**STATE SIGNIFICANT INFRASTRUCTURE
ASSESSMENT:
*Rapid Transit Rail Facility
Tallawong Road, Rouse Hill
(SSI 13_5931)***

Director-General's
Environmental Assessment Report
Section 115ZA of the
Environmental Planning and Assessment Act 1979

January 2014

Figure 5 Stormwater Basin - Indicative layout plan

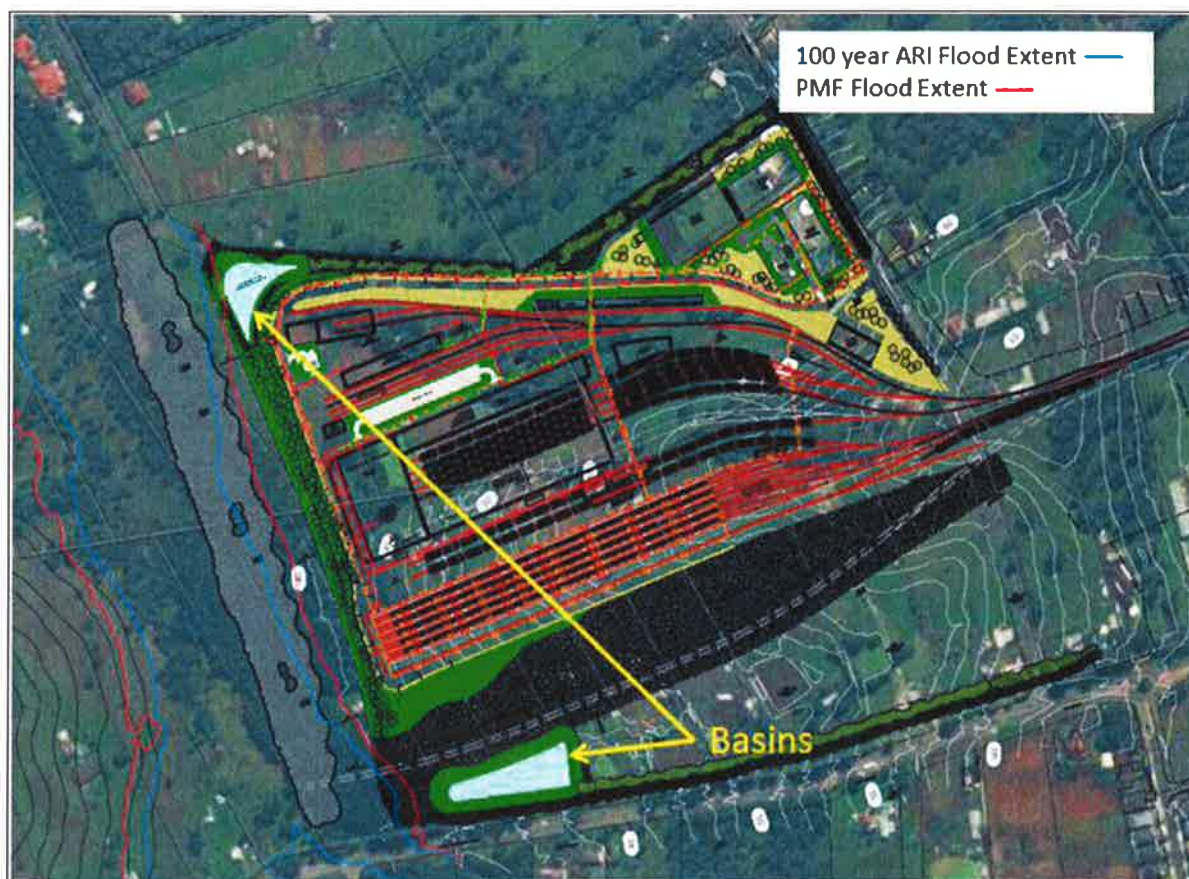
The indicative location of the stormwater detention basins is along the western boundary of the RTRF site as shown in **Figure 5**. At these locations the basins are located outside the 100 year ARI (the design standard for new developments), however the embankments do encroach upon the PMF floodplain. The Proponent determined that the basins would still function as per the required design standard.

Blacktown City Council made comments in relation to the indicative stormwater management strategy regarding First Ponds Creek. Council considers that any works that result in an encroachment upon the current 100 year flood extent will require a flood impact assessment to ensure no adverse impacts on flooding occur, including loss of flood storage. There are existing flood affected properties and dwellings in the vicinity of the site and therefore it will be necessary to ensure there is no increase in flood affectation (including frequency of flooding) and associated flood damages for the full range of ARI events from 1 year through to 100 year associated with First Ponds Creek and its tributaries.

Council further considers that the reported detention storage volume of 7,600m³ over a site area of 35.48ha gives a storage rate of 214m³/ha which appears low and should be checked thoroughly as part of the design of the project. Additionally, the proposed area of bio-retention of 3,000m² appears to be on the low side but reasonable, and the proposed configuration for the systems should further consider the potential salinity and groundwater impacts and determine whether lining of the system is required.

The Department has recommended that a Stormwater and Flooding Management Plan be prepared, in consultation with the Department (Strategies and Land Release), OEH and Blacktown City Council, during detailed design of the RTRF and prior to construction. The Plan is to include the identification of flood risks, the performance criteria, and mitigation measures that are proposed to be implemented to protect proposed works and not exacerbate existing flooding.
